Access Compliance Report

Public Rights-of-Way

(Curb Ramps)

Intersection ID: 29638	Main Street: COLONY_RD	Cross Street: SUMMERLIN_PL	Location: W
ADA ID: D9E8821C18BB	Ramp Type: ParaDiag	Initial Pass/Fail: Fail	Overall Compliance: No
Severity Score: 13.75			
Codes/Mitigation Info/Possible Solution		Field Measurements/Component Compliance

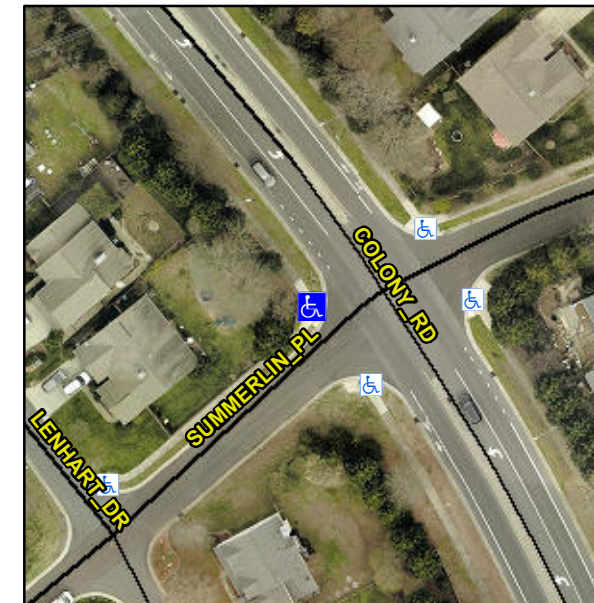
R304.3.2, R304.5.3

Compliance	Description	Data	Compliance	Description	Data
N/A	Ramp Length LT (in)	36.0	N/A	Ramp Length RT (in)	40.0
Yes	Ramp Width LT (in)	101.0	Yes	Ramp Width RT (in)	102.0
No	Ramp Slope LT (%)	8.4	Yes	Ramp Slope RT (%)	6.1
No	Ramp XSlope LT (%)	3.9	Yes	Ramp XSlope RT (%)	0.0
N/A	Landing Length (in)	N/A	N/A	DWS Provided?	N/A
N/A	Landing Width (in)	N/A	N/A	DWS Contrast?	N/A
N/A	Landing Slope (%)	N/A	N/A	DWS Length (in)	N/A
N/A	Landing X Slope (%)	N/A	N/A	DWS Full Width?	N/A
N/A	Landing Curb? (Y/N)	N/A	N/A	DWS Offset (in)	N/A
N/A	Shared Landing?	N/A			
N/A	Gutter Ponding?	N/A	N/A	Gutter Slope (%)	N/A
N/A	Gutter Lip Ht (in)	N/A	N/A	Gutter X Slope (%)	N/A
N/A	Painted X Walk1?	No	N/A	Painted X Walk2?	No
	X Walk 1 Direction	To SE		X Walk 2 Direction	To NE
N/A	X Walk 1 Width (in)	N/A	N/A	X Walk 2 Width (in)	N/A
	X Walk 1 Slope (%)	1.3		X Walk 2 Slope (%)	3.4
	X Walk 1 X Slope (%)	2.5		X Walk 2 X Slope (%)	1.6
N/A	Ramp inside XWalk1?	N/A	N/A	Ramp inside XWalk2?	N/A

Road Slope (%)	1.6	N/A	Clear Space?	N/A
	Road X Slope (%)	4.1	N/A	Clear Space to XWalk (in)	N/A
N/A	Any Obstructions?	N/A	N/A	Storm Grate/Utility Hazard?	N/A
	Obstruction Type			Storm Grate/Utility Type	
		N/A			N/A
			Yes	Surface Condition? (G/P)	Good
			N/A	Curb Slope (%)	6.1

Remove & Replace Curb Ramp With Two New Directional Ramps or Equivalent.
